## Land Development Notice Plan Review LD-15-04

Title of Plan Submitted: Pennsylvania State University Abington Student Apartments

**Re: Staff Review Comment on Application LD-15-03 for the property located at  
1001 Old York Road, Abington, Pa. 19001.**

Re: MCPC #15-0158-001  
Plan Name: Penn State Housing  
(1 lot/86 DU on 2.43 acres)  
Situate: Old York Road (E)/South of Rydal Way  
Abington Township

Attachments: Reduced Copy of Applicant's Plan  
Aerial of Plan Site

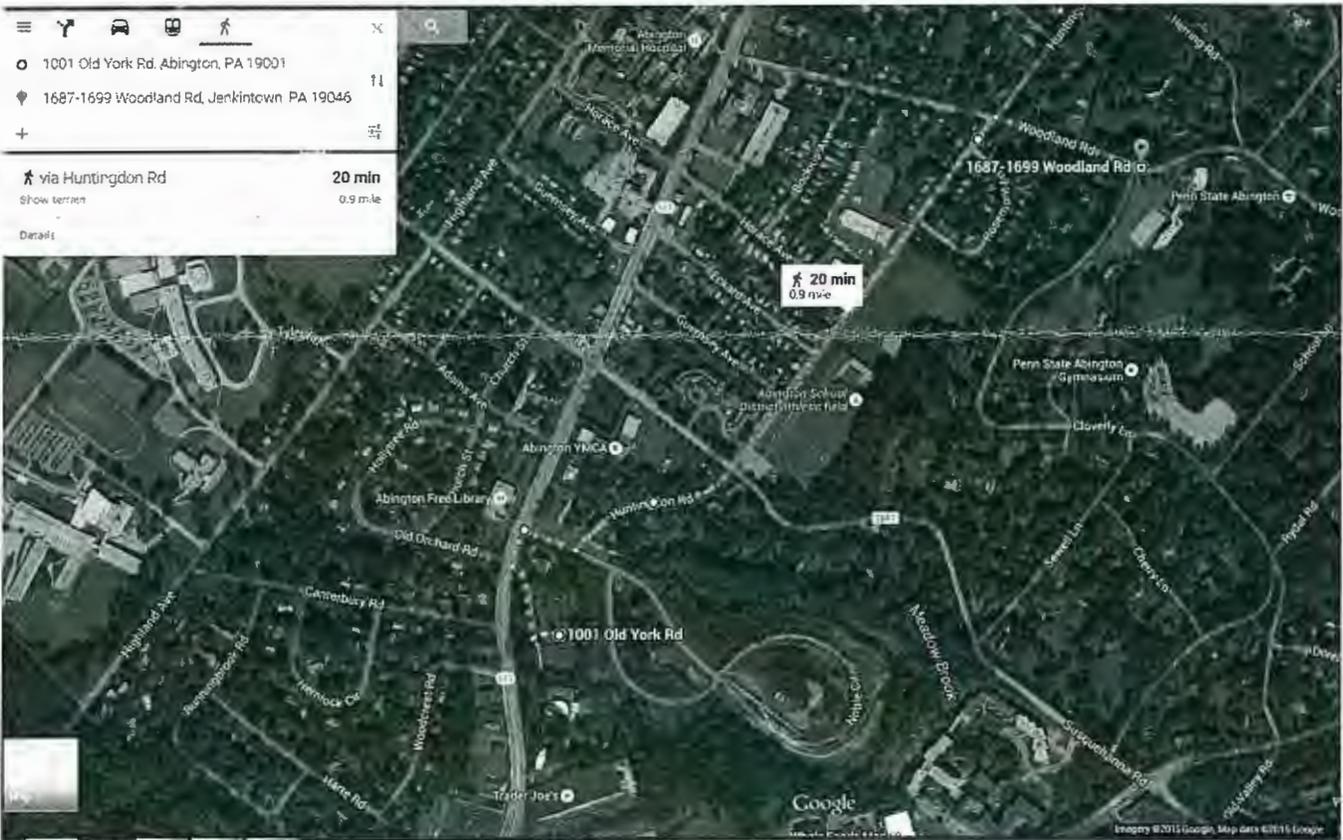
1. Potential Jaywalking – Students walking to campus from the apartments may use Huntingdon Road (online mapping shows this is a couple minutes faster walk than by walking through the intersection of Old York and Susquehanna Roads). However, there is no way to cross Susquehanna Road at Huntingdon Road without jaywalking. The Township may want to consider putting signs saying "cross at light" at this intersection, and putting up signs warning vehicular traffic on Susquehanna Road of pedestrians in the vicinity of Huntingdon Road.

2. "Sidewalk Continues" Signage – Consistent with the advice of Penn State's Community Relations Director, we recommend that a sign be erected on northbound Old York Road informing pedestrians that the sidewalk continues (it continues on the eastern branch of Old York Road, but many pedestrians cross over that to the island (this crossing is hazardously wide for pedestrians). The pedestrians crossing in such a way then walk along the western branch of Old York Road, although there is no sidewalk there.
3. Bus Stop – There is a bus stop on the WWII Memorial Island. We recommend adding a crosswalk and pedestrian signage so that pedestrians can safely cross to the island from the sidewalk on the eastern branch of Old York Road.
